Winnetka Park District

Elder and Centennial  
Park and Beach Project Presentation

October 13, 2021

**USACE and IDNR FEEDBACK and RESPONSES**

Planting Pocket imagery and drawings

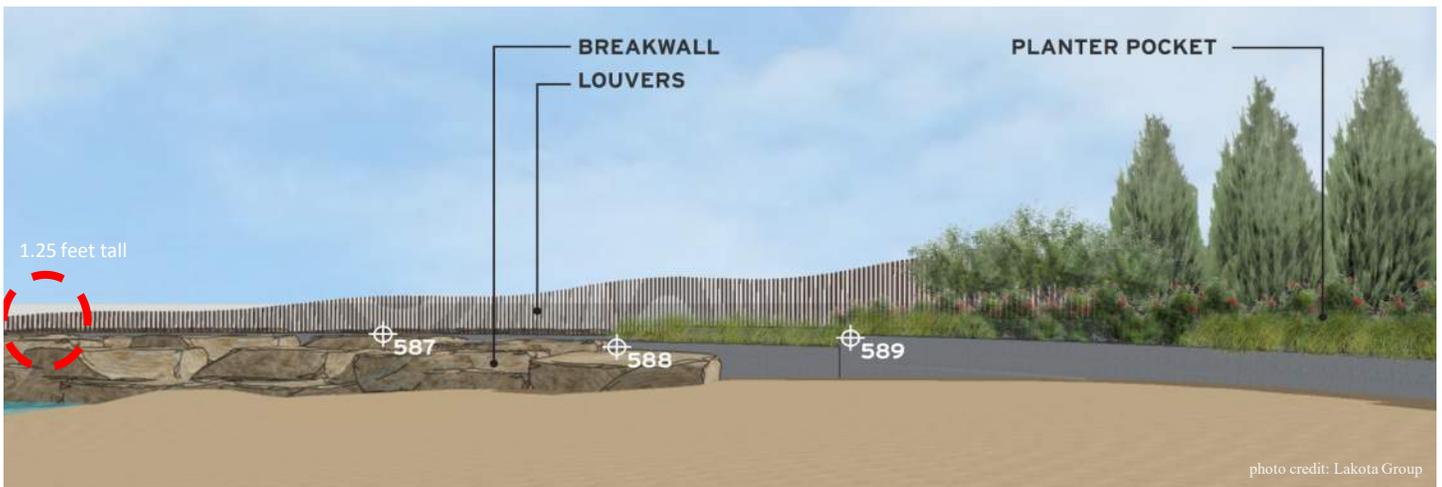
**Items #3 and #4** – *“We have substantial concerns with the proposed louvered wall with regard to blocking access along the shoreline and aesthetics. We have historically required reasonable accommodations for pedestrian movement along the shoreline and anticipate doing so on this project as well.”*

The proposed planting pockets will continue to lessen the “fortress” feeling and will bring vegetation and greenery down the bluff to the beach level to enhance the outdoor environment and beach experience. The pockets narrow as they extend lakeward and give way to the stone groin, thus creating a more aesthetically pleasing transition.

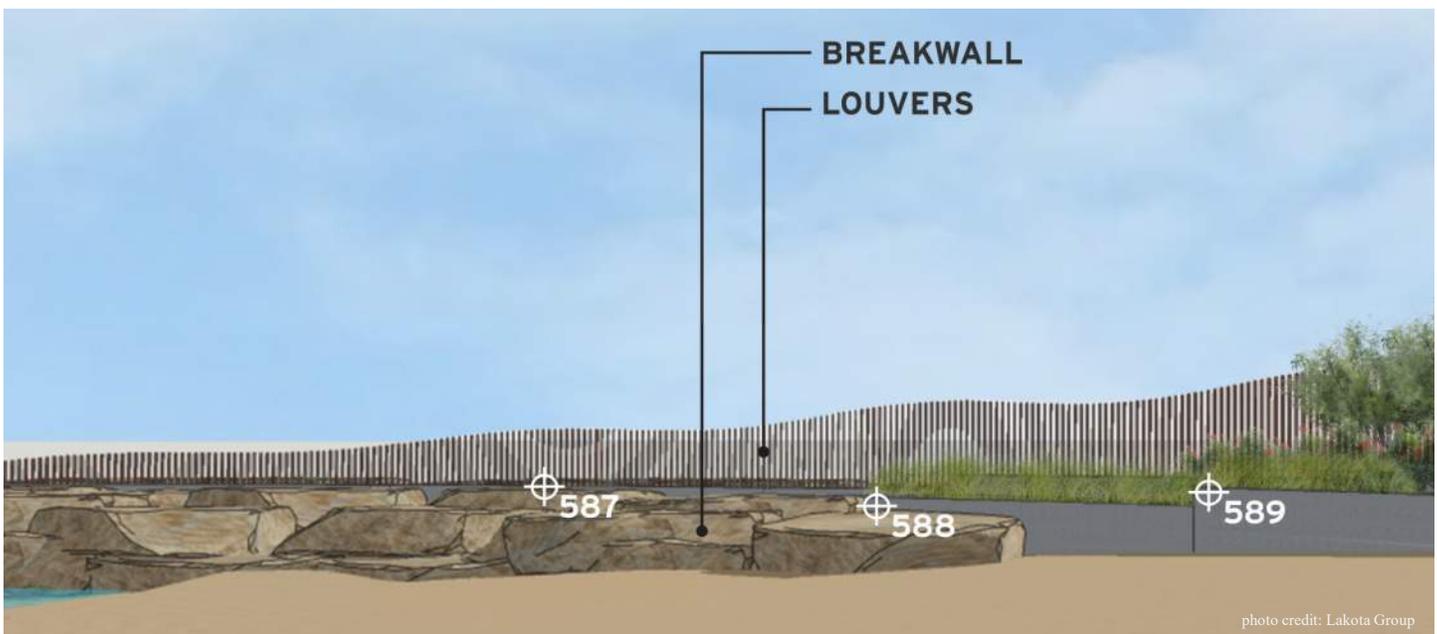
**Item #5**– “Although we acknowledge that efforts have been made to design the wall to limit visual obstructions, it could still potentially block views along the shoreline, particularly for individuals outside of the park boundaries. If the application includes a proposal for a louvered wall, the purposes of the wall must be explained as to how it satisfies defined needs.”

**Response to #5 (views):**

The Park District recognizes that shoreline vistas and water horizon line views are two key benefits of lake front environments and has taken steps to preserve them.

Multiple views along the shoreline, from both inside and outside park boundaries, are shown on the preliminary images below and on the following pages – and demonstrate how the groin extension guardrails do not block shoreline vistas and water horizon lines. The higher elevation bluff and tableland views are even less impacted than the beach views.
